**Trial Application of
API RP 2A — WSD Draft Section 17**

Volume I — Summary Report

by
PMB Engineering Inc.
San Francisco, CA

Final Report

Figure 1-1 Section 17 - Platform Assessment Process
Metocean Loading

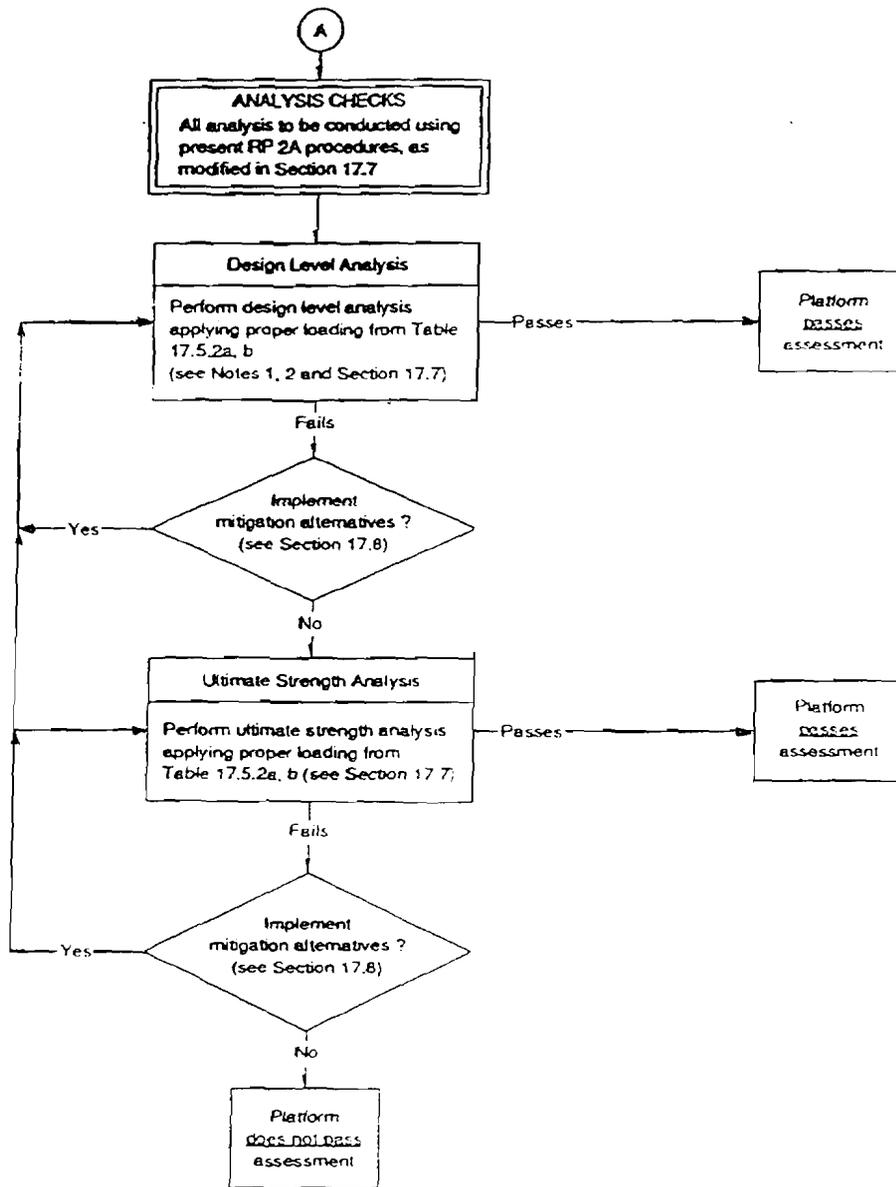
- Another participant stated that all platforms will need to be assessed per Figure 17.5.2. API TG noted that there may be a need for an additional block in Figure 17.5.2 clarifying the API requirements for Gulf of Mexico platforms installed prior to 1977.

All the triggers to perform assessment should be included in the flow chart of Figure 17.5.2 to make it more complete.

- 3a. The assessment process flowchart (Figure 17.5.2) does not reflect a check to determine if platform damage or increased platform loading is significant according to Section 17.2.6. Some analytical work is necessary to determine if the damage or increased loading is significant. The analytical work may show the damage or increased loading to be insignificant and, if no other initiators exist, the platform passes assessment. This process for an alternative design level analysis is discussed in Section 17.5.2.3.

1. Figure 17.5.2, Page 6, Note 1: "Design Level Check". It is not clear if what is meant is a "Design Level Analysis" or "Design Basis Check".
2. This Section makes the following statement

Based upon the discussion held at the meeting, the API TG updated Figure 17.5.2 in their June 28, 1994 revision.

1. The Draft version of Section 17 which will be published by the API shows assessment initiators in Figure 17.5.2 with a question regarding regulatory requirements. The decision to reference assessment initiators, rather than state them explicitly in the flowchart, was based upon space limitations.

1. The flowchart in Figure 17.5.2 is being changed to read "Design Level Analysis"
2. The statement in 17.6.1 is more precise; however, opinions differ as to the preferred wording. There is currently a reference to Section 17.6 at the end of the first paragraph in 17.5.2.

Figure 4-5

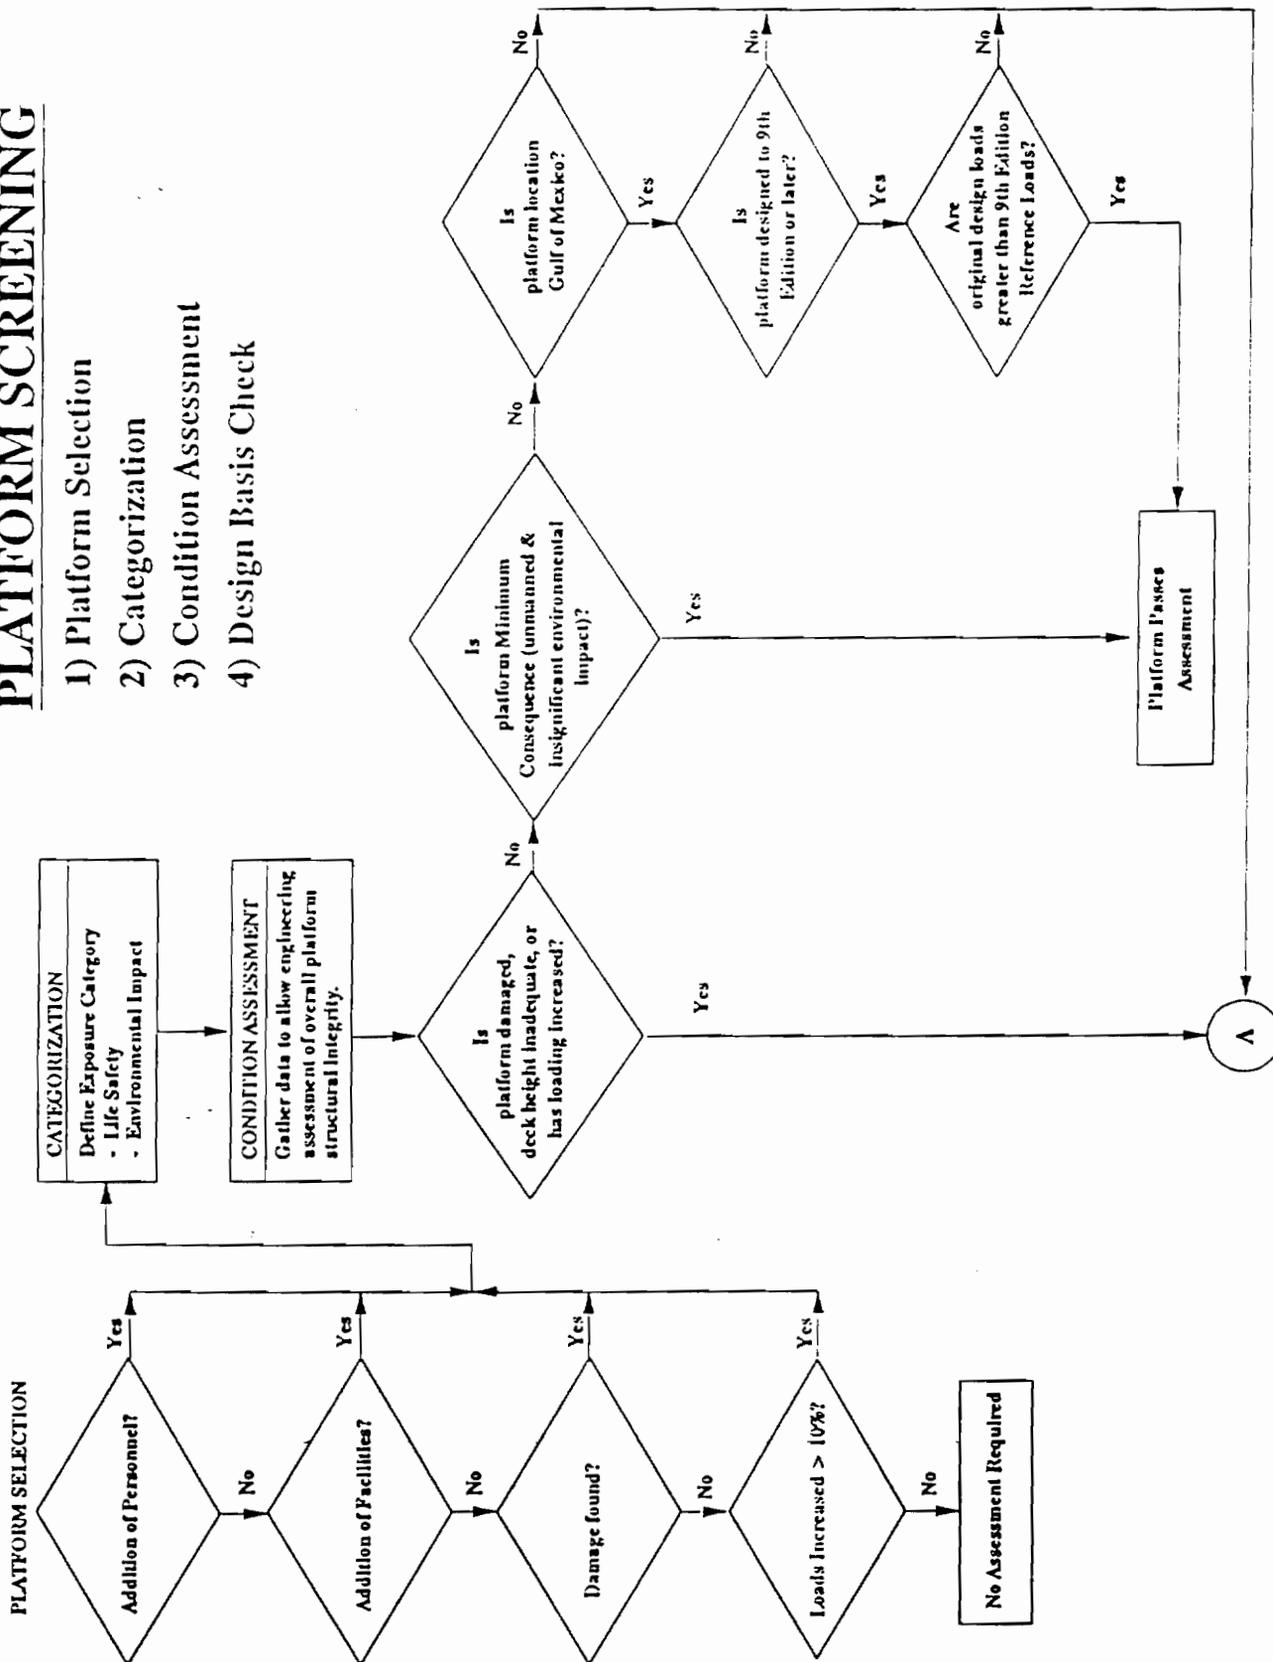
- 4a. In Figure 17.5.2 there needs to be a mechanism in the flow chart which allows a termination to the assessment process when it is determined that no personnel or facilities are being added and there is no significant damage or load increase. A proposed revision to the flow chart is attached at the end of this section (see Figure 4-5).

Figure 4-4

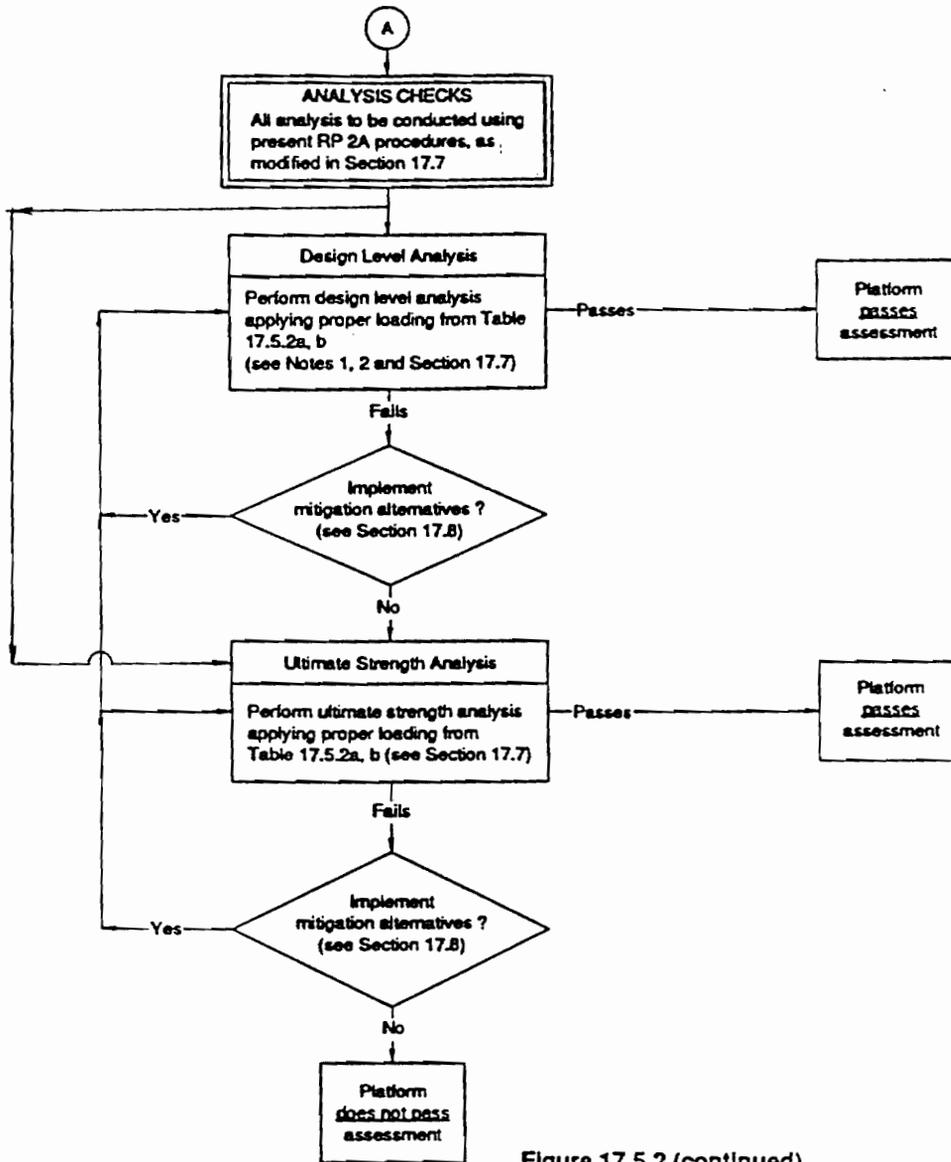
- 2b. (p.5) First paragraph read as "-----". However, it is permissible to bypass the design level analysis and to proceed directly with an ultimate strength analysis. -----. This option should be reflected in Figure 17.5.2 (continued) – page 7 (see Figure 4-4).

Figure 5-1: Variations of Minimum RSR and Capacity Ratio for Gulf of Mexico Platforms According to Category

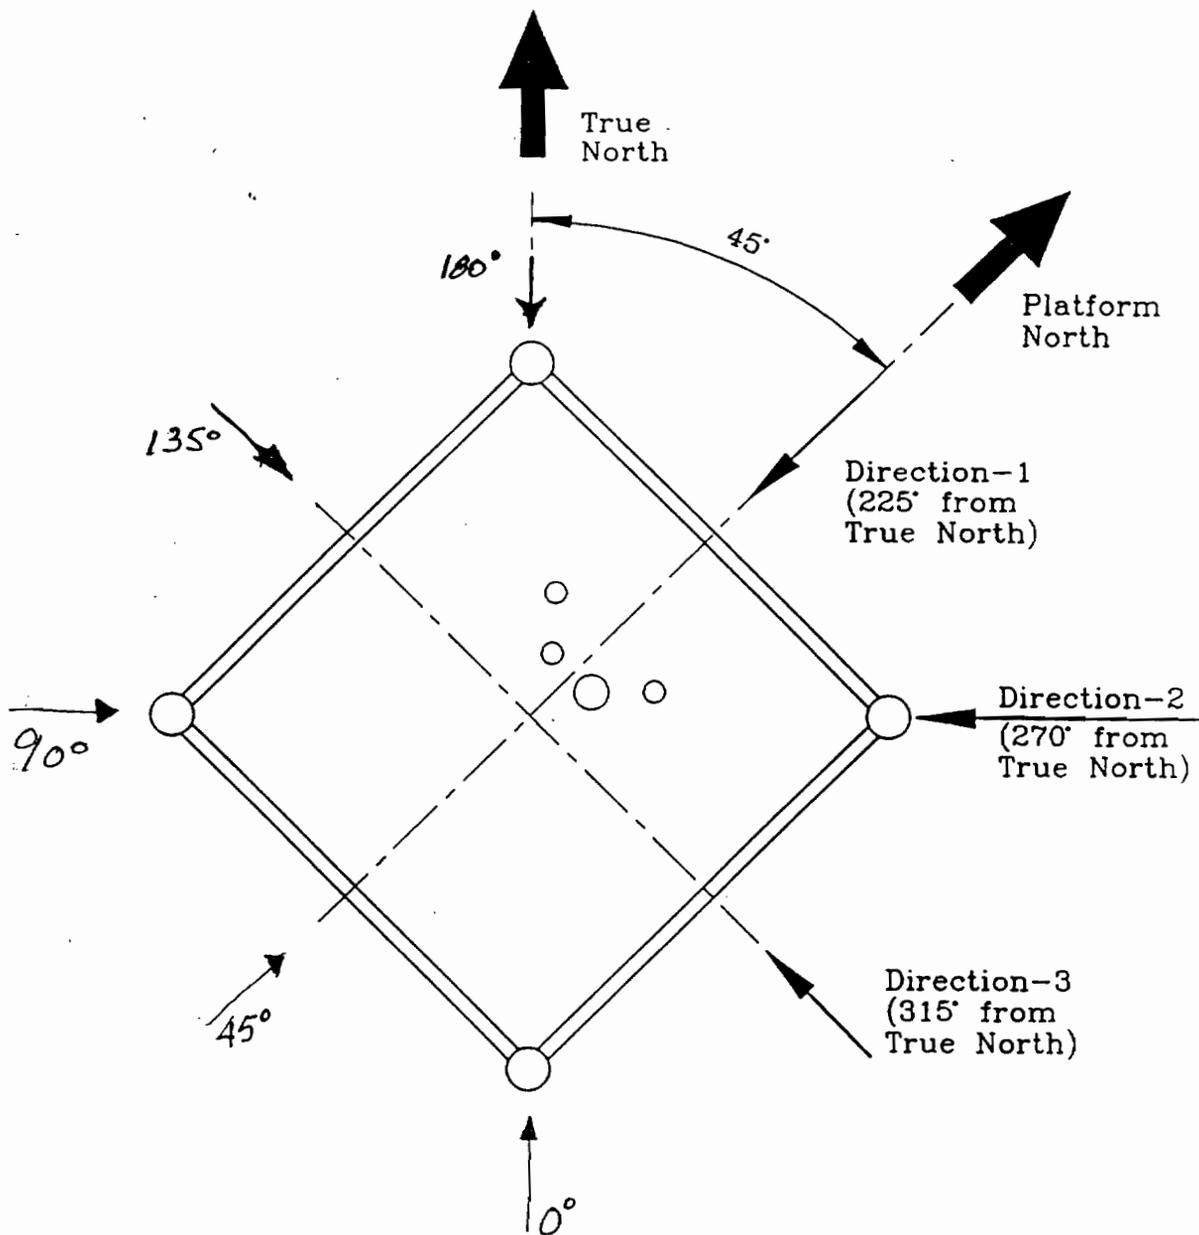
This figure indicates that three platforms (A, H, and N) clearly do not meet the Section 17 criteria due to their (Ru/S-17) ratio being about 0.59 to 0.85. Platform A is in damaged state.

This figure indicates that under the Full Population category, two platforms, L (RSR-1.18, 4-leg) and P (RSR-1.12, 8-leg), have RSR's which are marginally lower than 1.2 used by API. Platform P is a special case with a diagonal bracing pattern oriented in the same direction on both longitudinal frames, thus resulting in a lower RSR.
